विषय— Agenda Item No.1 01 Diversion of 0.35 ha of forest land for constreuction of Bandwaldhar Jarmwar to Bainji Kandai Motor Road in favour of PWD, within the jurisdiction of Rudraprayag Forest Division, District Rudraprayag, Uttarakhand (Proposal No. FP/UK/Road/155241/2022)।

सन्दर्भ— भारत सरकार की दिनांक 30.10.2023 को हुई FRCM की बैठक एवं अपर प्रमुख वन संरक्षक एवं नोडल अधिकारी, वन संरक्षण, इन्दिरानगर फॉरेस्ट कालोनी, उत्तराखण्ड, देहरादून के पत्र संख्या 927/1जी-5095(रा0रा0प्रा0) देहरादून, दिनांक 09.11.2023।

Subject: Submission of geological site assessment report of 3.0 Km long Chopra Udamanda (PMGSY) motor road to Banwaldhar (Jarmwaad)-Benji-Kaandai (SC Basti) motor road.

Geological Assessment of 3.0 Km long Chopra Udamanda (PMGSY) Motor Road to Banwaldhar (Jarmwaad)- Kaandai (SC Basti) Motor Road
Agastmuni Block, District Rudraprayag
Dr. Tushar Sharma
26/11/2022

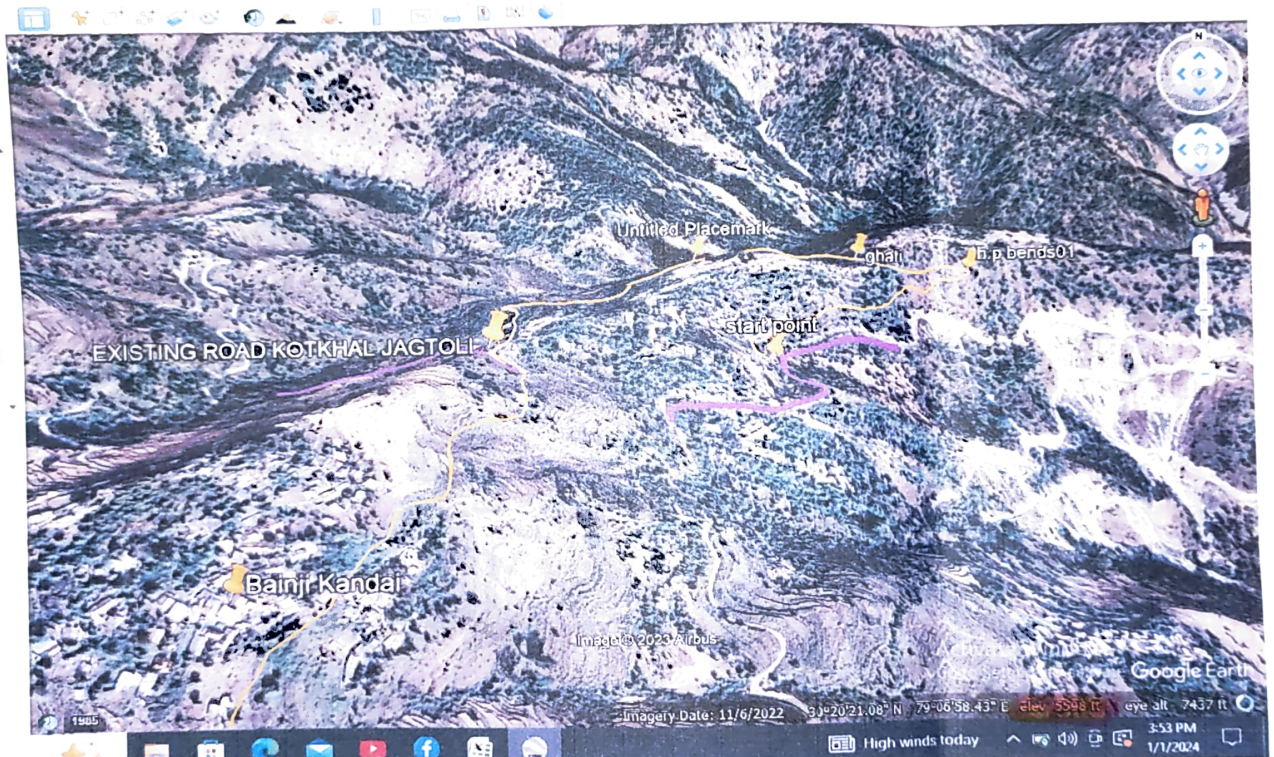
क्र०सं०	आपत्ति	आपत्ति का निराकरण
1	After detailed discussion, it was decided that the DFO may visit the site along with the local engineer and geologist. They may reexamine that steep slope and explore alternate to avoid steep forest area which is above the prposed alignment.	ग्राम बैंजी काण्डई के समीप एक मोटर मार्ग निर्मित है, परन्तु मोटर मार्ग से बैंजी काण्डई गांव की एलवेशन दूरी 115 मीटर है। शासन के पत्रांक 167/111(2)/18-15(सामान्य)/2018 दिनांक 31.12.2018 द्वारा प्राख्यापित सड़क मार्ग नीति के बिन्दु संख्या 4 के अनुसार मार्ग से 100 मीटर की वर्टिकल दूरी तक स्थित गांव /बसावट को ही मोटर मार्ग से संयोजित माना जाता है। विषयगत प्रकरण में गांव 100 मीटर से अधिक वर्टिकल दूरी पर स्थित है। अतः ग्राम बैंजी काण्डई मोटर मार्ग से असंयोजित है। विषयगत मोटर मार्ग का भू वैज्ञानिक द्वारा पूर्व में निरीक्षण किया जा चुका है। जिससे उनके द्वारा मार्ग के आरम्भ के भाग को भौगोलिक दृष्टिकोण से स्थिर पाया गया, सुलभ सन्दर्भ हेतु भूवैज्ञानिक की रिपोर्ट संलग्न है। विषयगत मार्ग को RIDGE के ऊपर ले जाना इसलिए सम्भव नहीं हो पा रहा है, क्योंकि ग्रामीणों के अधिकांश परिसम्पत्तियां अर्थात् मकान, पंचायत घर, RIDGE पर बने हुए हैं।

ELEVATION DIFFERENCE

(A) - BAINJI KANDAI - 5947.00 FT

(B) → EXISTING ROAD KOTKHAL JAGTOLI - 5598 FT

DIFFERENCE → 349 FT

⇒ 106.40 MTR
